Ordinance: ORD-0045-2023

AN ORDINANCE TO AMEND THE OFFICIAL ZONING MAP OF THE CITY OF GAHANNA ADOPTED BY ORDINANCE 198-96 ON NOVEMBER 19, 1996, AND SUBSEQUENTLY AMENDED; CHANGING THE ZONING DISTRICT OF +/- 16.666 ACRES LOCATED AT 0 HAMILTON ROAD, PARCEL ID 025-013767 FROM LMFRD AND SCPD TO LMFRD; CRESCENT WOODS APARTMENTS, GRIFFIN CALDWELL, APPLICANT; AND DECLARING AN EMERGENCY

PROPERTY INFORMATION		
Project/Property Address: 0 Hamilton Road		Project Name/Business Name: Crescent Woods Apartments
Parcel #: 025-013767	Current Zoning: <i>(see Map)</i> Select One	Acreage: 16.666

SITE PLAN - RESIDENTIAL

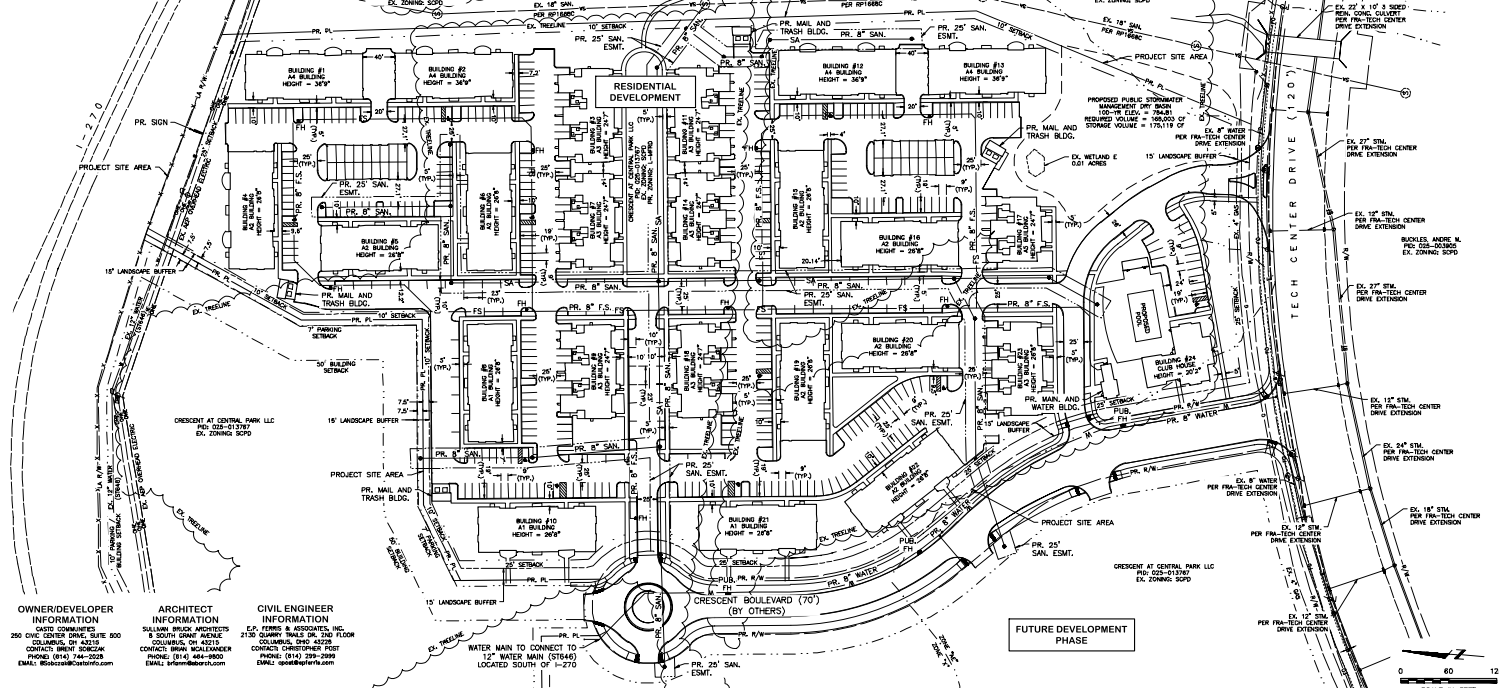
1. See comments on the Final Development Plan.

2. Chapter 1109.08 requires rezoning requests to MFRD to provide land for public parks or fees-in-lieu. A variance has been submitted to this section but no information has been provided as to what is being varied or what is being proposed. Please provide additional information to determine if a variance is required and what is being proposed. Please be aware that additional comments may be forthcoming based on response to comments. Please be aware that various staff members and the Parks and Recreation Board are required to provide recommendations based on the proposal.

Submitted Site Plan

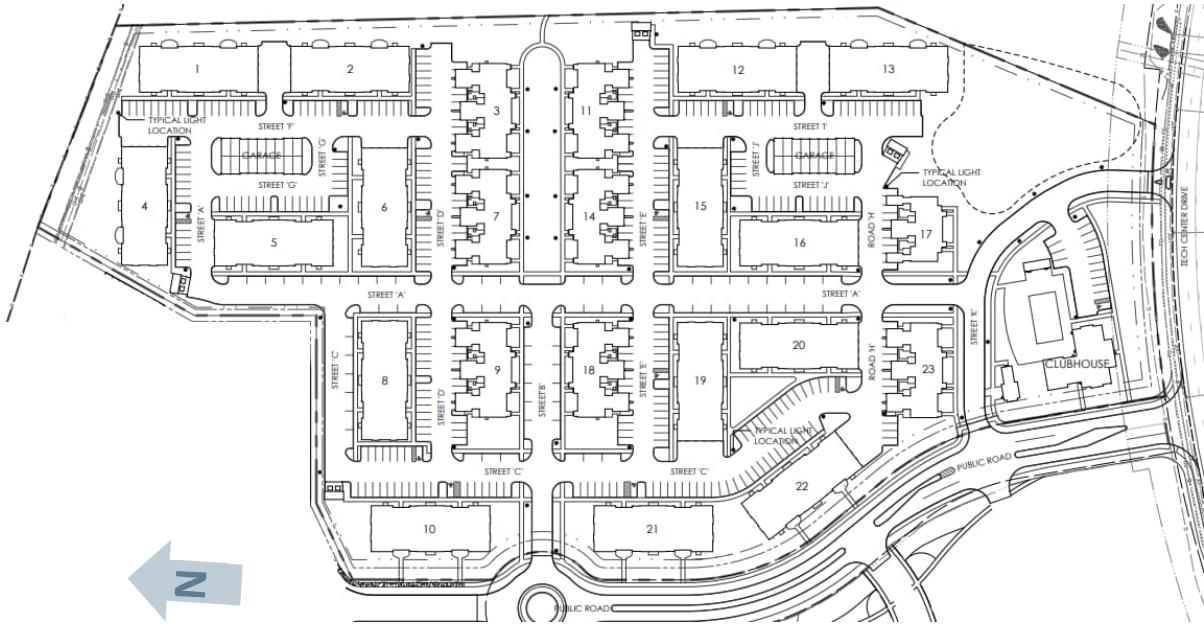
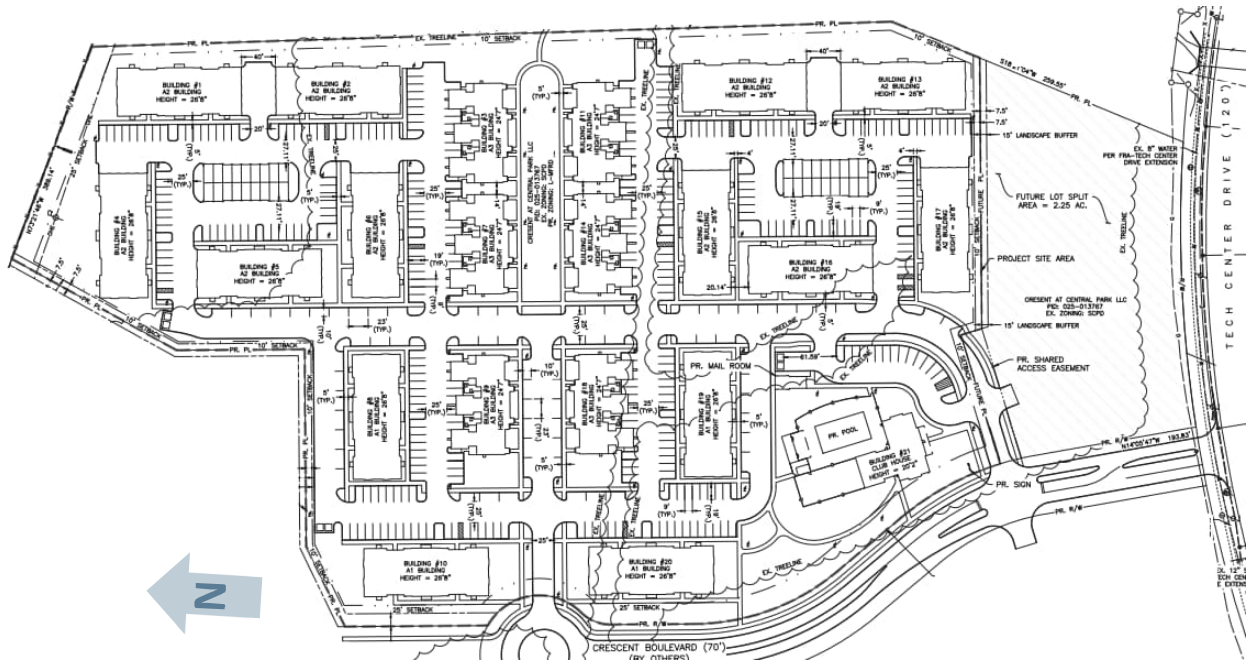
Staff recommends approval of the Final Development Plan, Variance, Conditional Use, and Rezoning as submitted. These four applications meet all applicable Code requirements and above criteria with the requested Variances. The requested Conditional Uses are necessary for higher density residential and have been recently applied to other multi-family developments. Additionally, the Land Use Plan identifies a need for more diverse housing options in the City as the region continues to grow. All of the requested Variances are either minor in nature, necessary to meet other Code requirements, and/or have been previously approved for this site.
